REGULAR MEETING OF THIRD LAGUNA HILLS MUTUAL ARCHITECTURAL CONTROLS AND STANDARDS COMMITTEE*

**Thursday, August 14, 2023 – 1:30 p.m.
Laguna Woods Village Board Room/Virtual Meeting
24351 El Toro Road, Laguna Woods, California**

NOTICE AND AGENDA

ATTACHMENT 4
APPLICATION PLANS

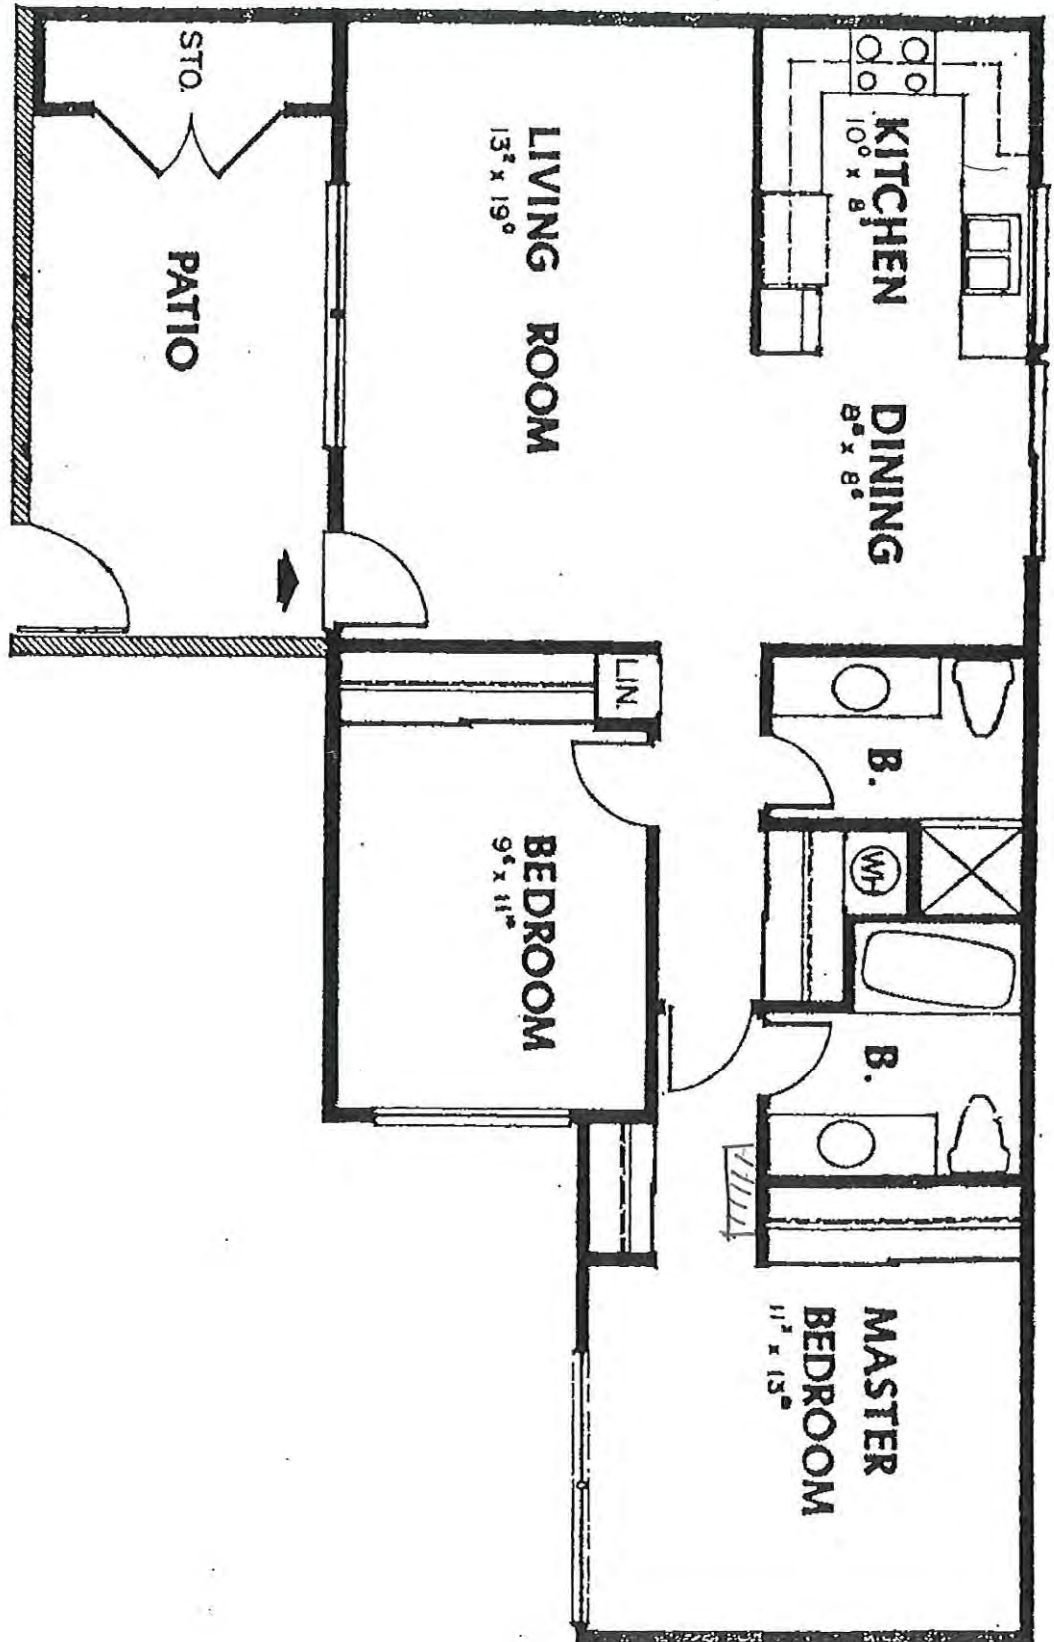
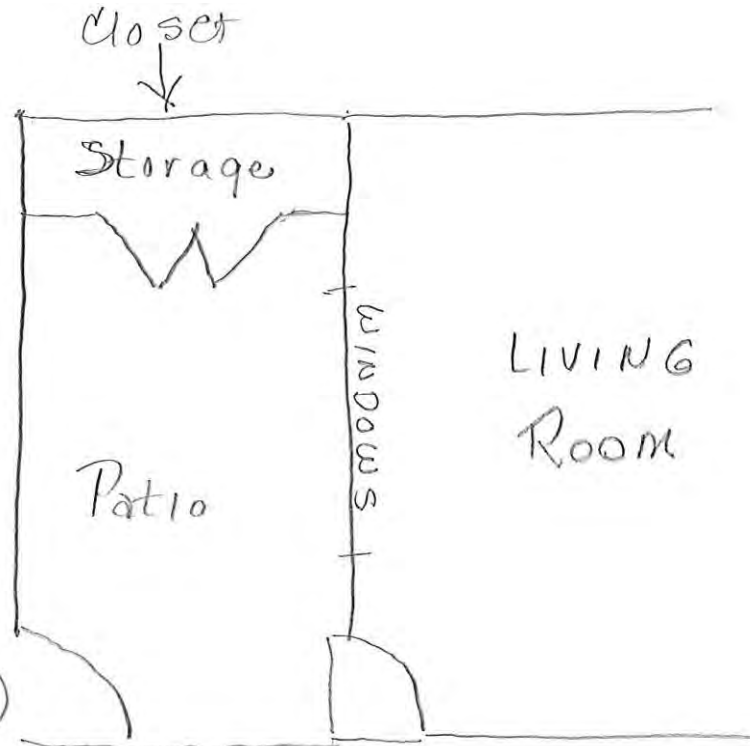
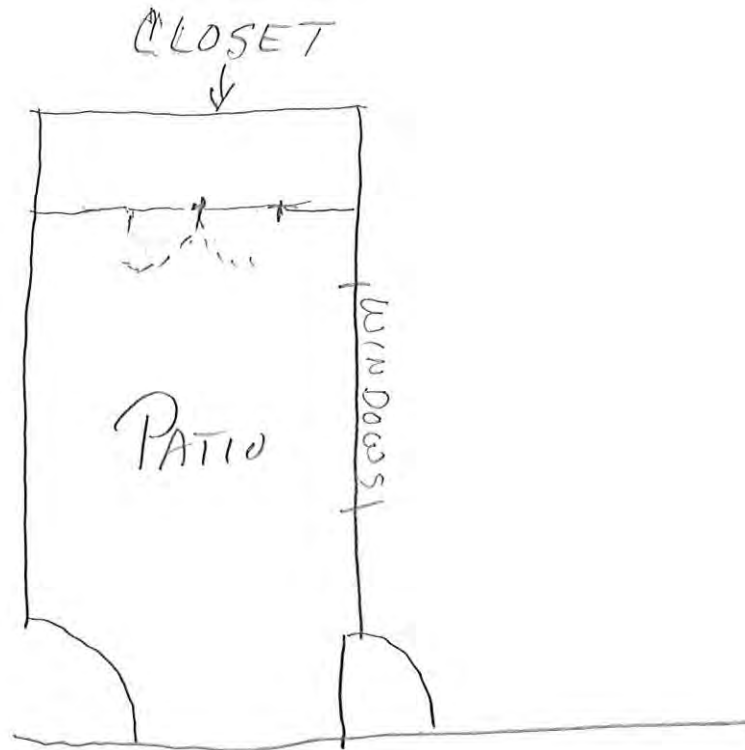
1. 3010-C is one of three manors at building 3010.
2. Original patio wall lowered with mutual consent as part of patio enclosure which was removed in 2023.
3. Closet is located on exclusive use common area patio space.
4. No additional common area is being utilized.

- A.3. The Member shall provide plans, specifications, and calculations from a duly licensed architect or structural engineer to conform to the Building Code for all foundation, framing, and beam additions for the work of this variance.

- A.4. A City of Laguna Woods Building Permit will be required and provided to Manor Alterations to verify all code requirements for new or modified structural components, and shoring have been satisfied.

4013-1D Remove rail at 6' x 15' Patio

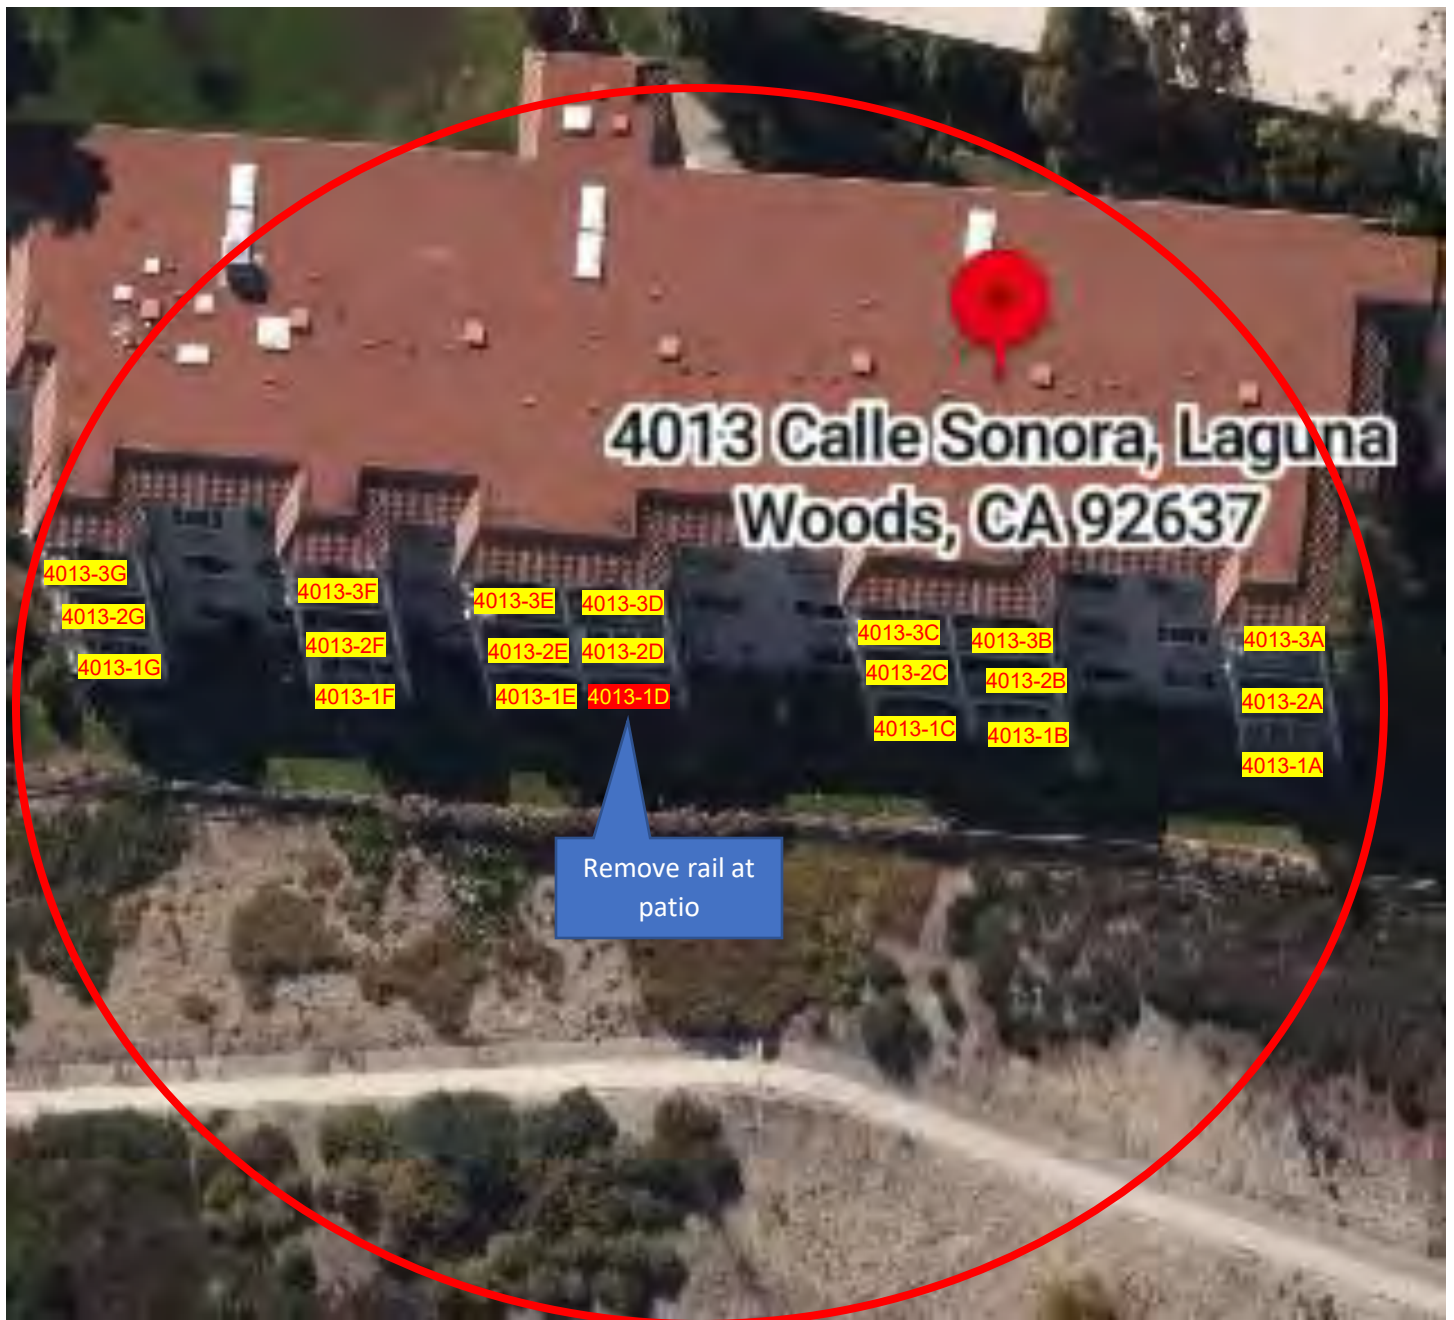
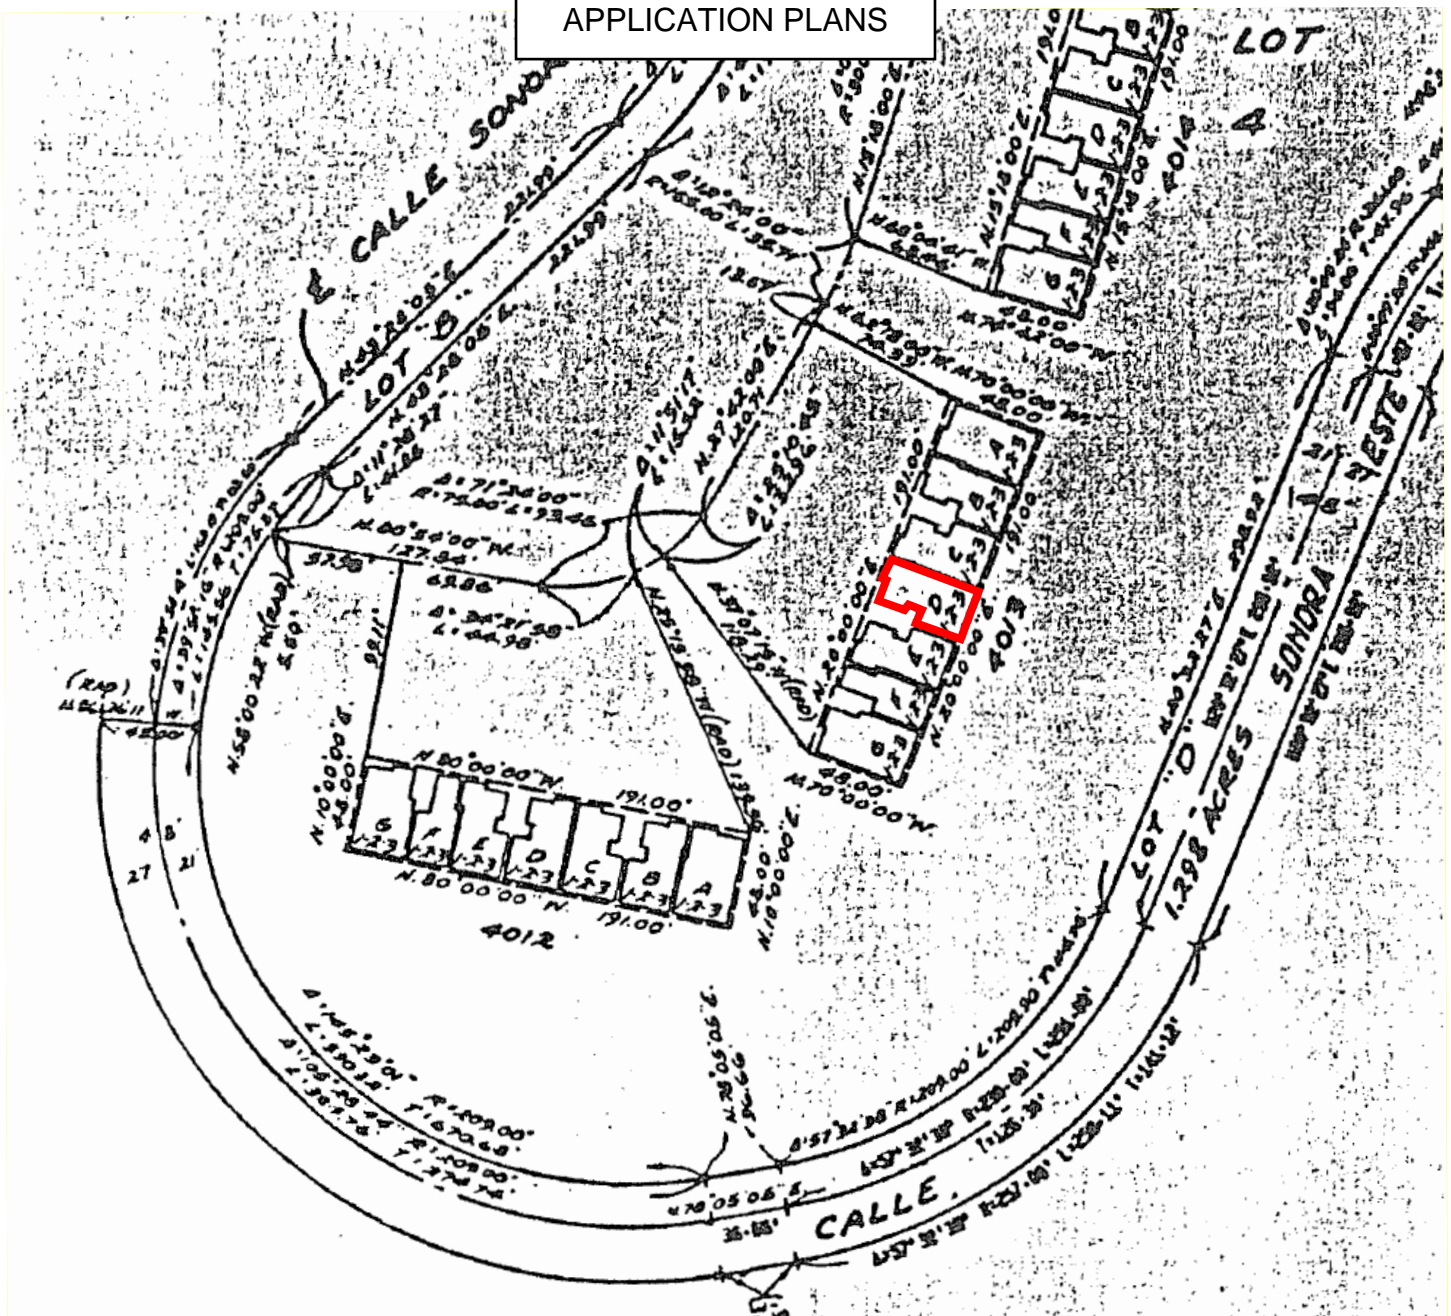
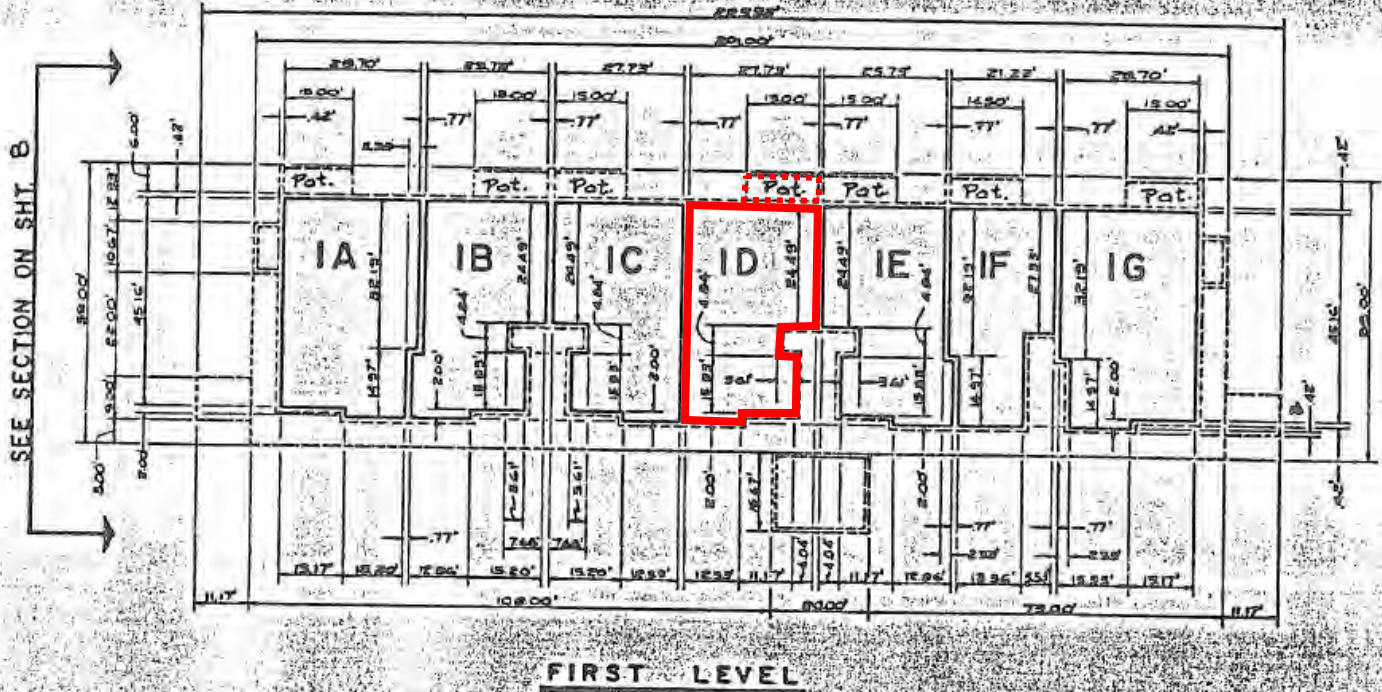
We propose to permanently remove the existing railing and gate from our first floor patio. The railing is not needed for safety reasons as the patio is on the first floor just 6 inches above the soil. The railing limits the amount of usable space and sits right at eye level when looking at our incredible view as shown in attached photos.

The other photos show that the first floor is not even visible from any other location or buildings. They also show existing and proposed railing views.

Variance Description: Remove Original Railing and Gate from Patio
